I-5 / 4th ST and 88th ST NE
Corridor Improvements

Tulalip Tribes Project No. 2026-014

ADDENDUM NO. 4 – August 5, 2026
to
Request for Bid Proposals

PLAN REF NO
SN5

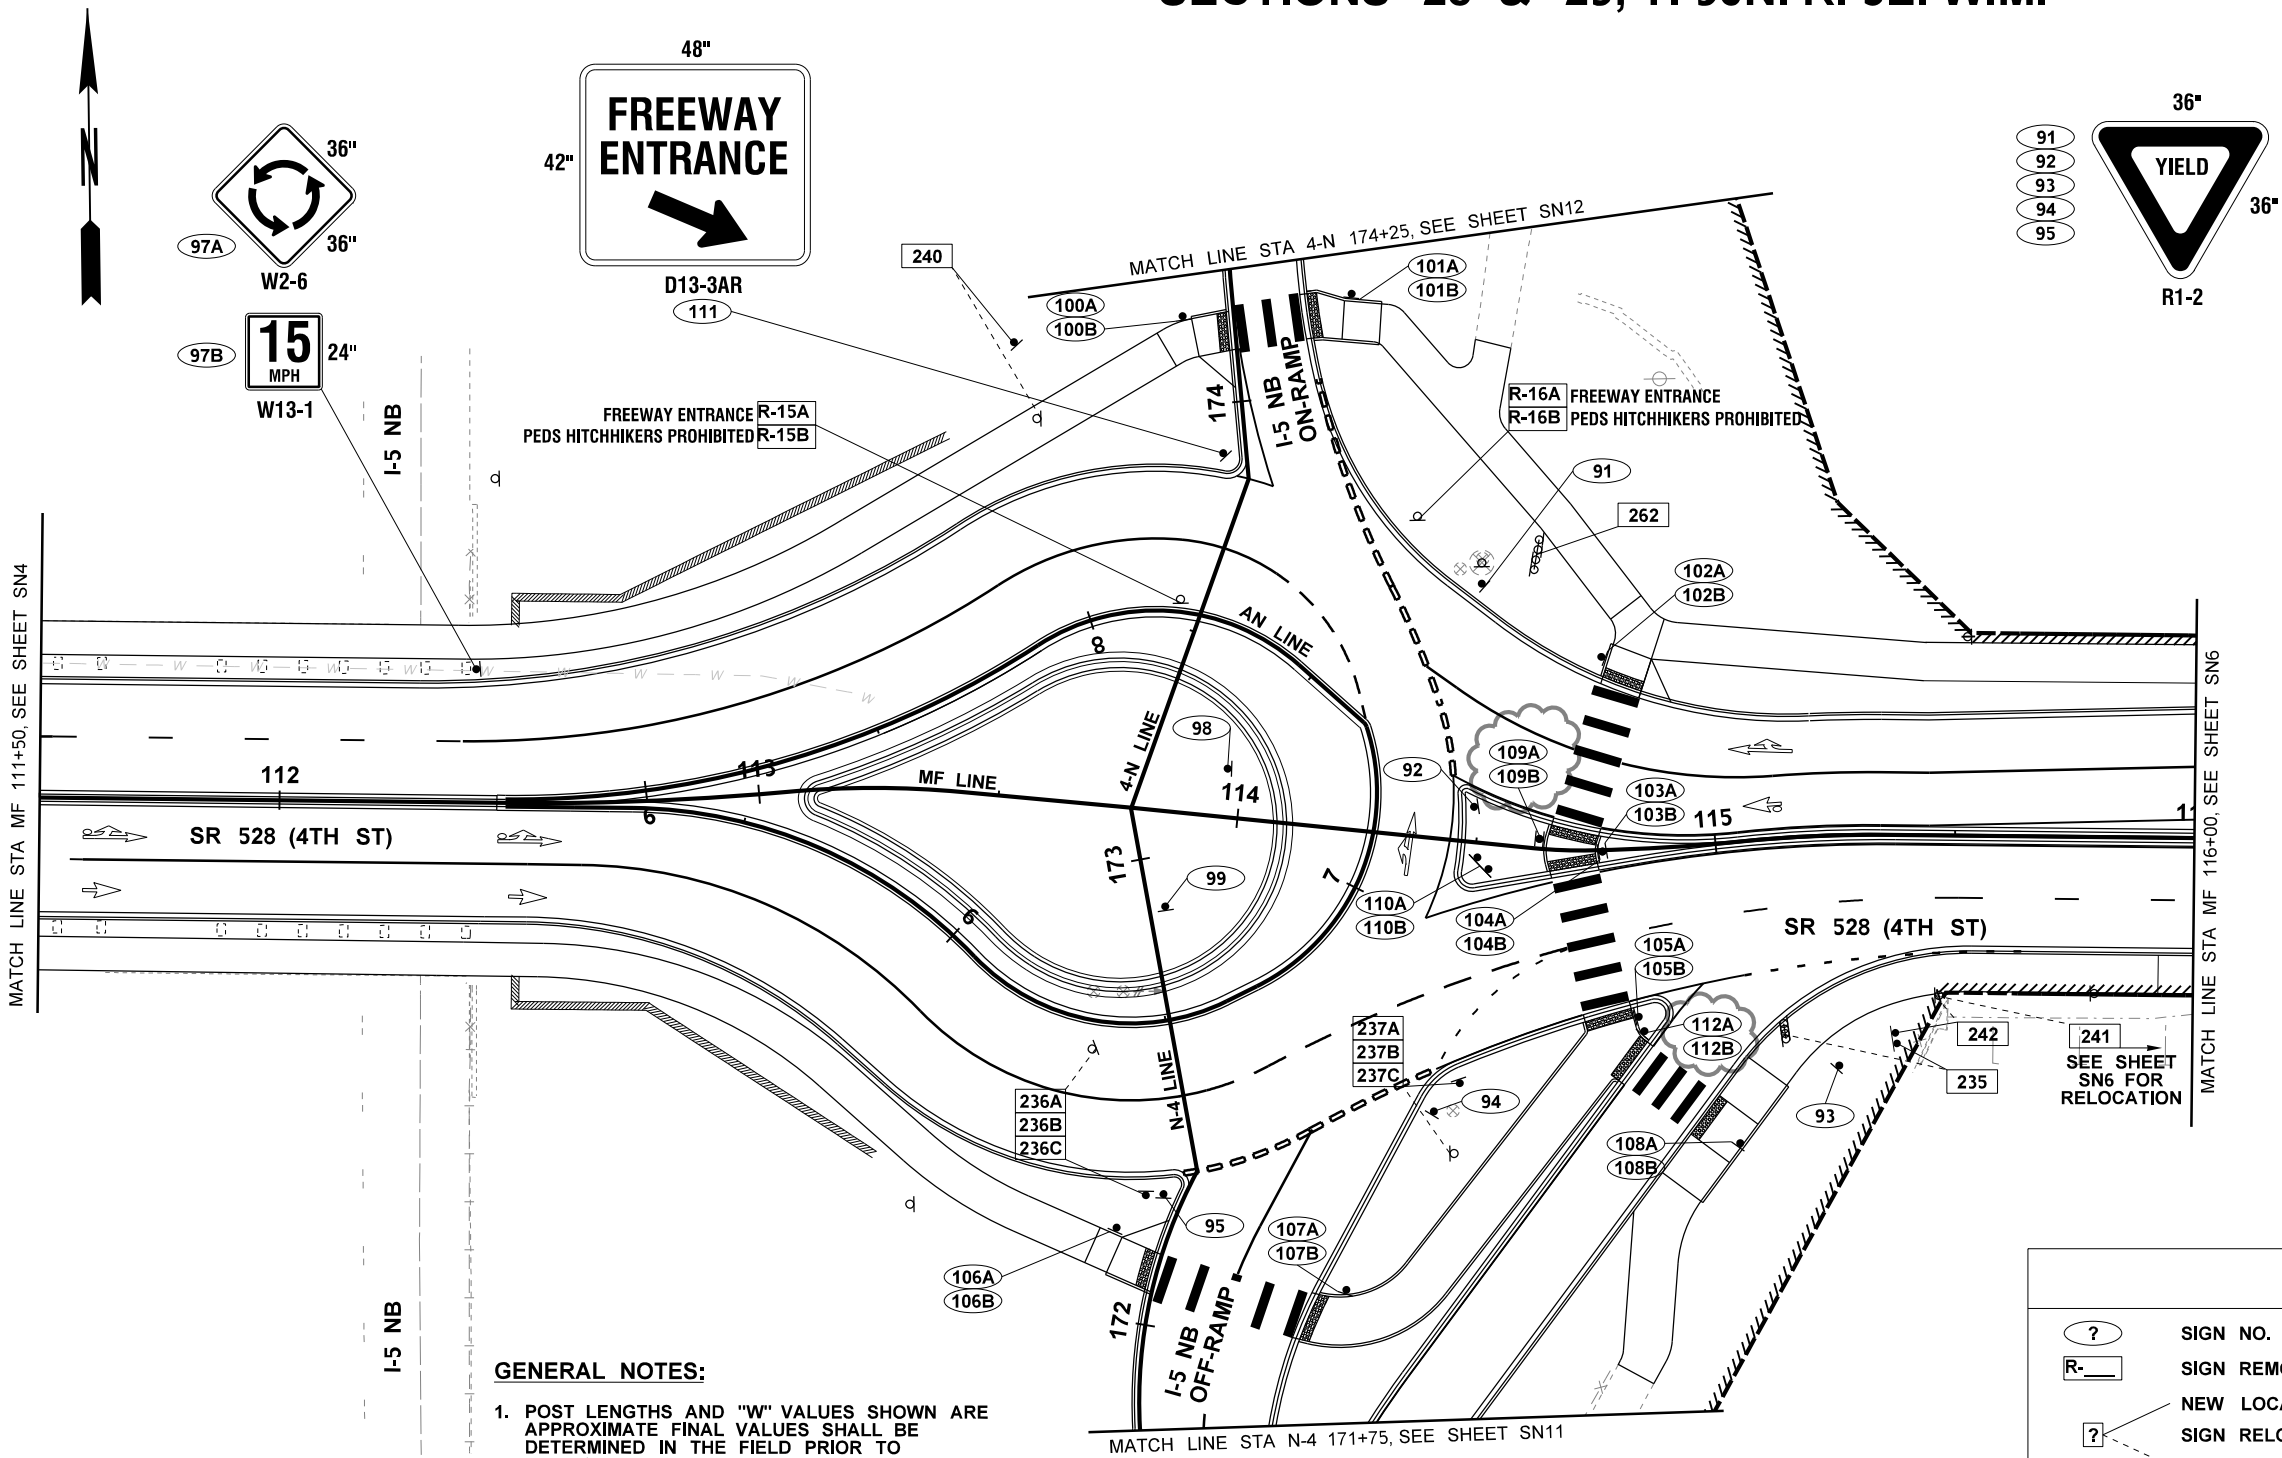
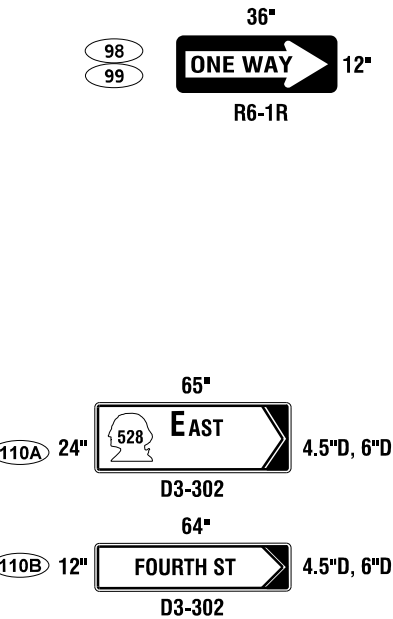
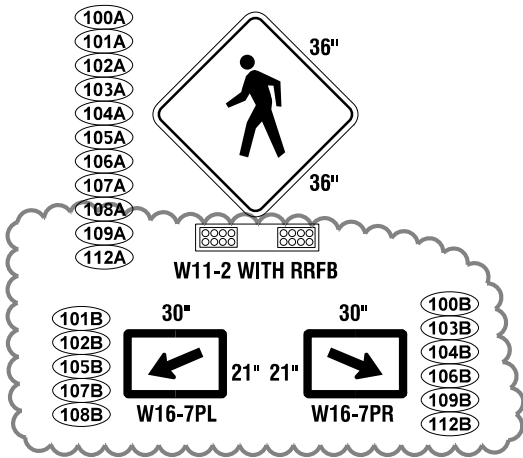
1. Volume 3
Sheets ILW8, RRFB Details - WSDOT; ILW9, Illumination & RRFB Notes and Schematics – WSDOT; SN2, SN4, SN5, Signing Plans; SS1-SS4, Sign Specifications.
2. Volume 4
Sheets ILW8, RRFB Details - WSDOT; ILW9, Illumination & RRFB Notes and Schematics – WSDOT; SN2, SN3, SN5, SN6, Signing Plans; SS1-SS4, Sign Specifications; WA1-WA6 SEW Wall plans.

I-5 / 4TH ST AND 88TH ST NE CORRIDOR IMPROVEMENTS VOLUME 3 OF 4	PLAN REF. NO. ILW9
ILLUMINATION & RRFB NOTES AND SCHEMATICS - WSDOT	SHEET 282 OF 323 SHEETS

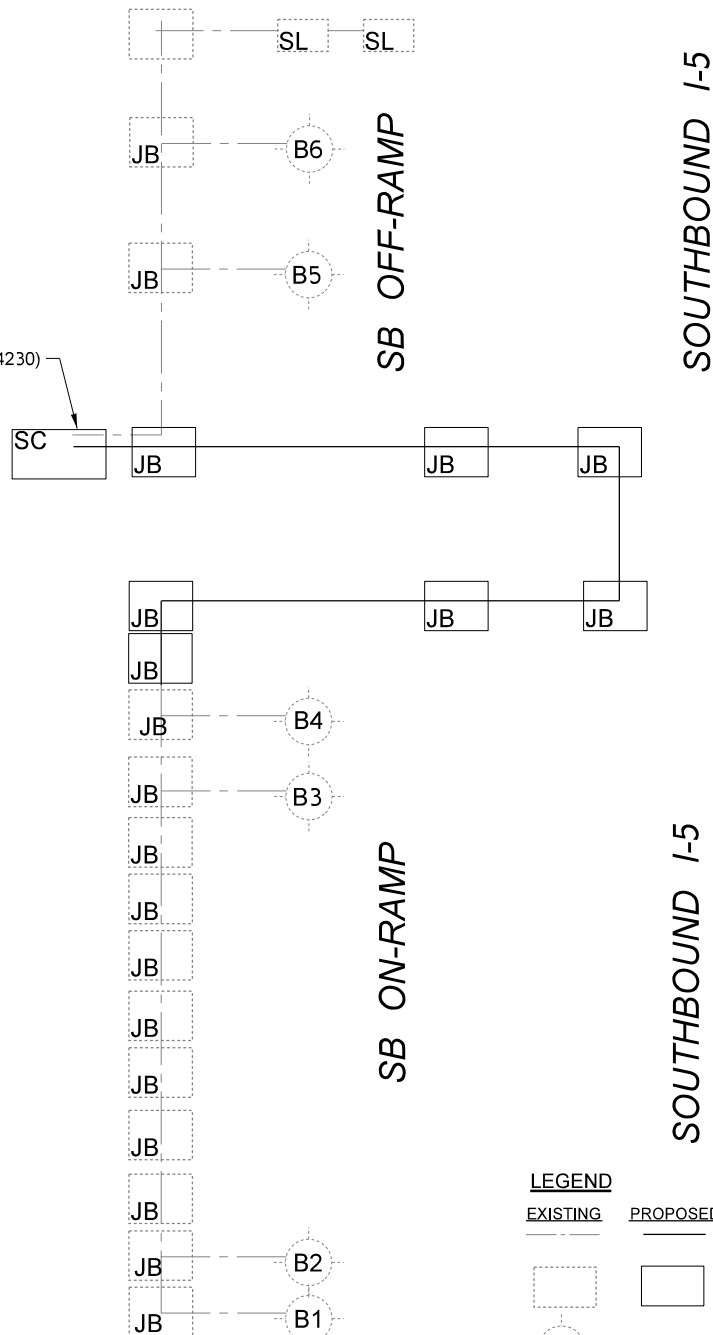
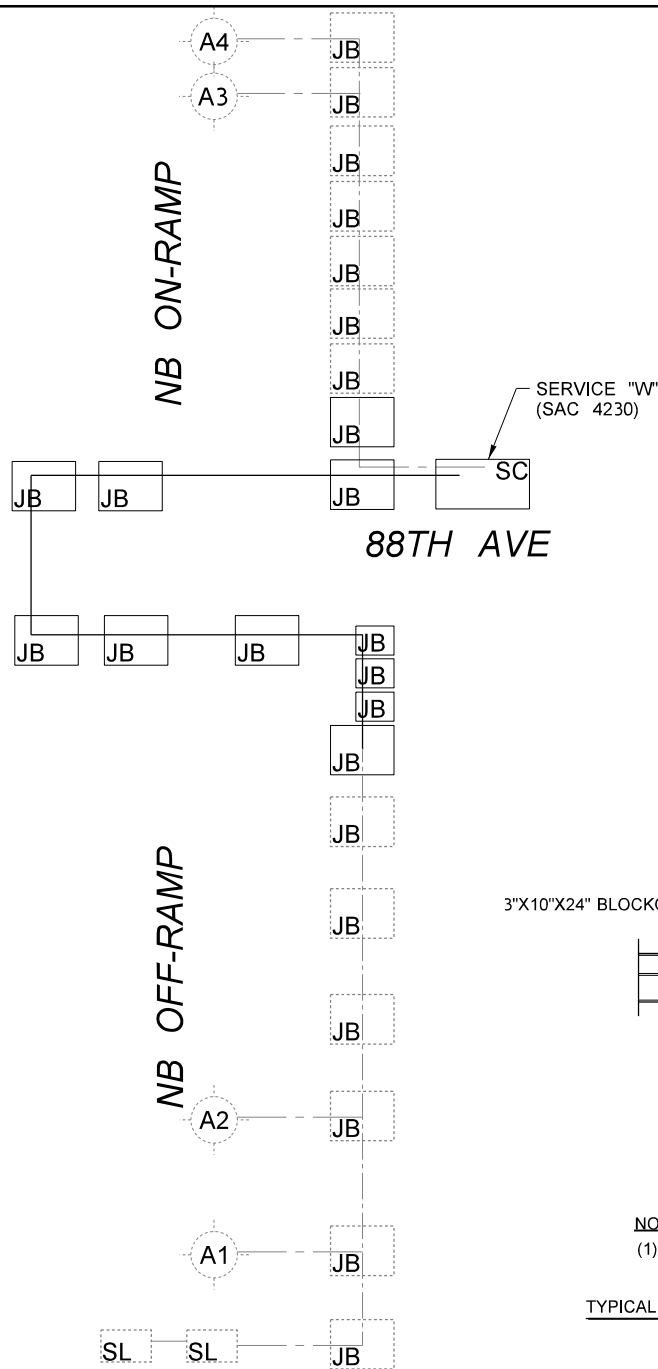
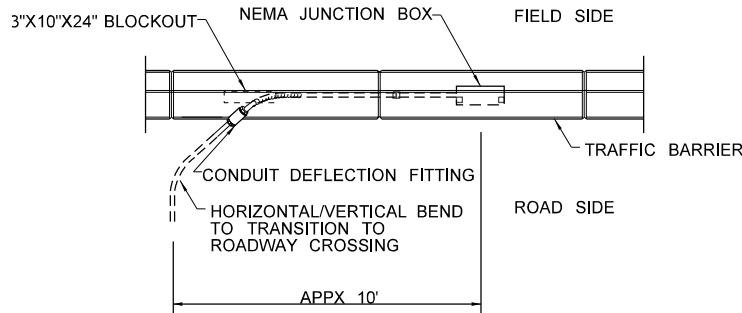
CHECKED BY S. OLLING																
PROJ. ENGR. H. LONGFELLOW		AD4 - REVISED RRFB POST AND SIGNAGE	8/4/2026	SO												
REGIONAL ADM.		REVISION	DATE	BY												
P.E. STAMP BOX DATE 8/4/2026 P.E. STAMP BOX DATE
